March 23, 2001  
NG-01-0382

Subject: Duane Arnold Energy Center  
Docket No: 50-331  
Op. License No: DPR-49  
Response to Request for Additional Information (RAI) to Technical  
Specification Change Request TSCR-037 – Alternative Source Term.  
(TAC # MB0347)

Response to Request for Additional Information

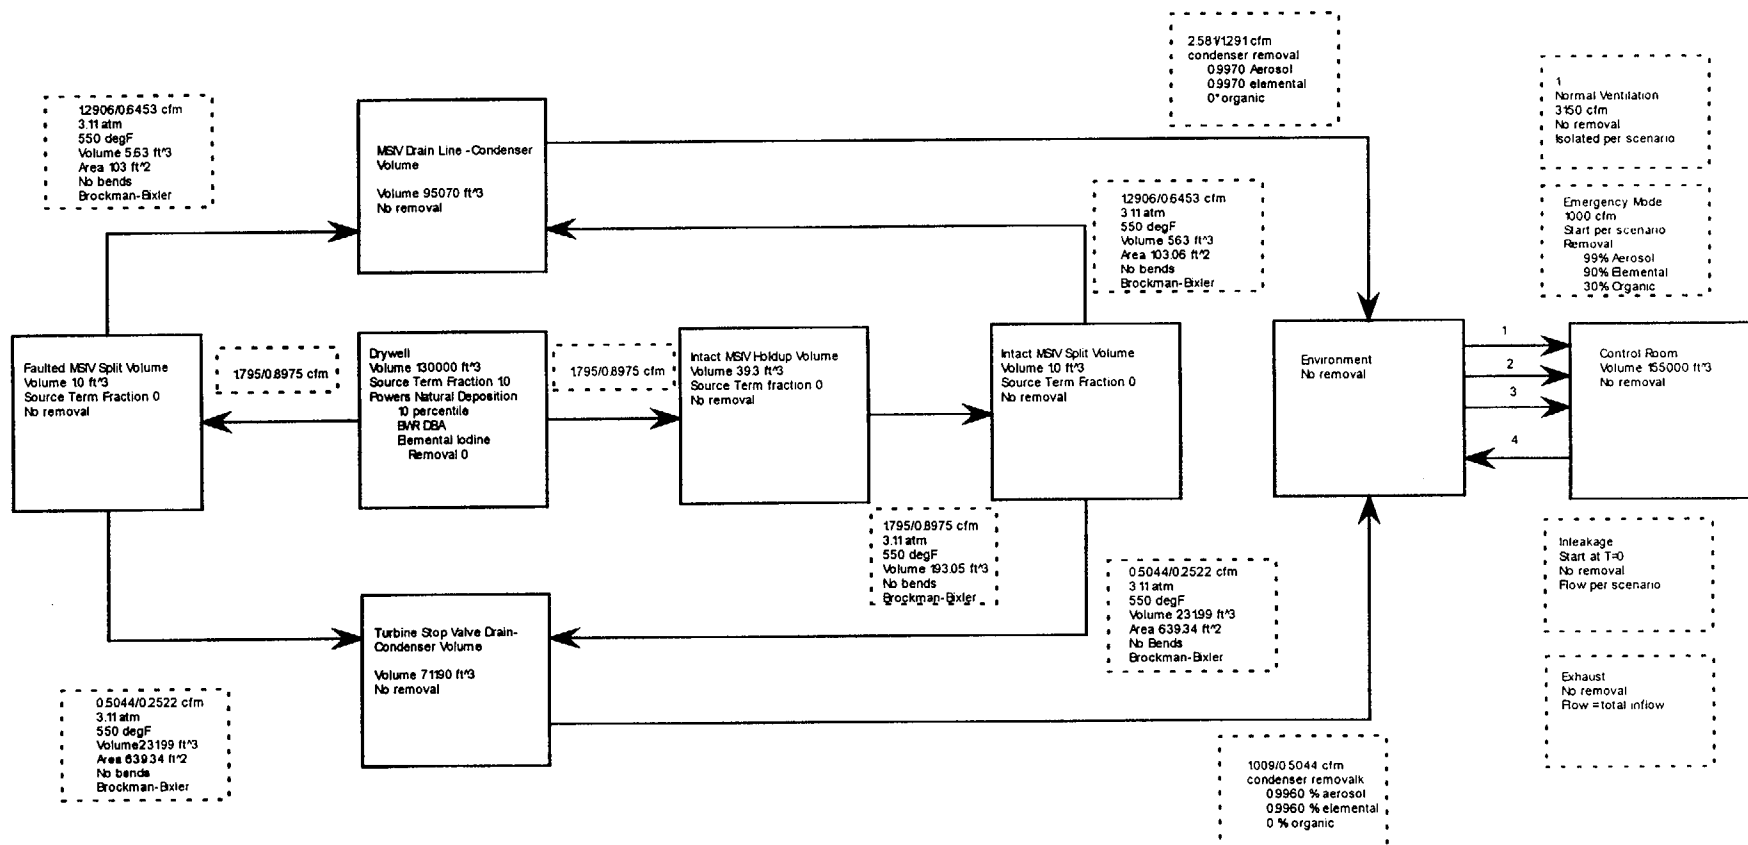
In additional discussions during our telecon related to the CRDA analysis, the impact of considering the release of 50% of the halogen inventory as compared to 30% in accordance with DG-1081 was raised. The write-up following these responses (CRDA Impact of Using DG-1081 Guidelines for Release Fractions) contains the results of our evaluation of this impact.

In the gap release the DG guidance releases 15% of Kr-85, 10% of the other Noble Gasses, 12% of I-131 and 10% of other Halogens, as compared to the 10% for each under the RG. The DG also releases 10% of alkali metals, but since they are particulates that are retained in the coolant, they didn't really enter into our analysis. We used the generic predictions for fuel clad damage and melt fraction. The gap release fractions for the DG include 12% of the I-131, 15% of the Kr-85 and 10% of the remaining Halogens and Noble Gasses. For the melt, 100% of Noble Gasses are released in both the DG and RG. In the RG, however, 50% of the halogens are to be released and the DG only required a net release of 30%.

The net difference is that 0.5845% of the core Kr-85 is released in the DG compared to 0.3993% in the RG, and, 0.4533% of the core I-131 is released in the DG compared to 0.3849% for the RG. For the other Halogens, however, the DG guidance releases 0.3791% rather than the 0.3849% expected under the RG.

The total inventory of Noble Gasses and Halogens released is  $2.23\text{E}+06$  curies for the DG and  $2.19\text{E}+06$  curies for the RG at  $T=0$ . To perform an estimate of dose consequences, we used half life calculations using our core inventory to identify the total release curie content at  $T=0$ ,  $T=2$  hours, and  $T=30$  days. We then used the cloudshine effective DCFs from RADTRAD for the isotopes to weight the inventory of each isotope relative to I-131. Clearly, the conservative DG fractions for I-131 and Kr-85 are important because over time their concentration remains higher due to their longer half lives. The DCF evaluation, however, accounts for the isotopes that may have greater impact on effective dose. This evaluation does not account for transport or removal. It simply compares the total CRDA release source term inventories for the DG and RG, adjusted for dose.

The initial conservatism of the DG release for KR-85 and I-131 does not quite compensate for the higher DCFs for the other Halogens, but the net difference at  $T=0$  is only 0.76%, which decreases to 0.27% at 2 hours. By the end of the 30 day analysis period, the DG results in about a 17.8% conservative dose consequence compared to the RG.

#### 3.6.4.1 Secondary Containment

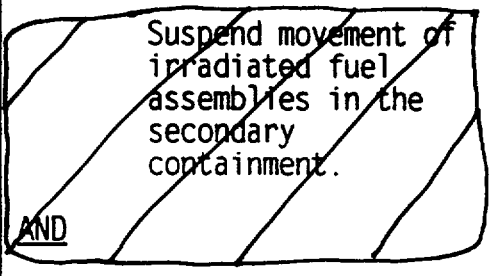
3.6-35	Remove "During movement of irradiated fuel assemblies in the secondary containment" and "During CORE ALTERATIONS," from the APPLICABILITY of LCO 3.6.4.1. Remove "movement of irradiated fuel assemblies in the secondary containment, during CORE ALTERATIONS, or during" from Condition C. Delete REQUIRED ACTION C.1, "Suspend movement of irradiated fuel assemblies in the secondary containment. <u>AND</u> " and delete associated COMPLETION TIME.

~~During movement of irradiated fuel assemblies in the secondary containment.~~

E.1 E.2 and E.3

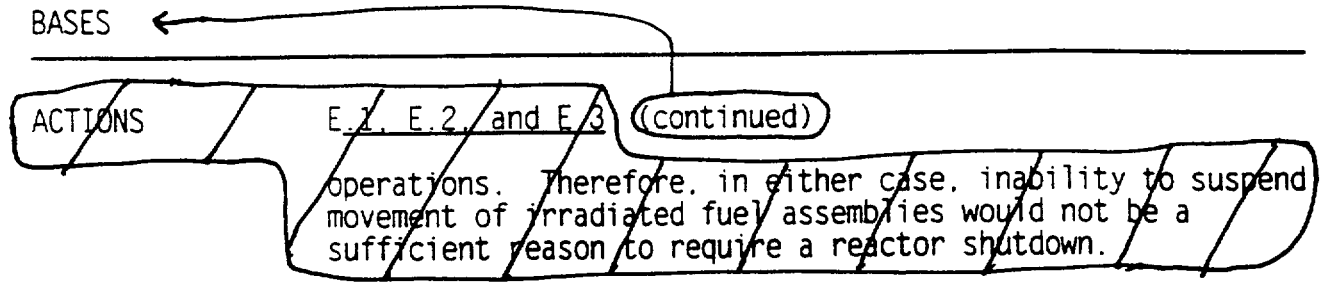
When two SBGT subsystems are inoperable, if applicable, CORE ALTERATIONS and movement of irradiated fuel assemblies in secondary containment must immediately be suspended. Suspension of these activities shall not preclude completion of movement of a component to a safe position. Also, if applicable, actions must immediately be initiated to suspend OPDRVs in order to minimize the probability of a vessel draindown and subsequent potential for fission product release. Actions must continue until OPDRVs are suspended.

When OPDRVs  
can occur
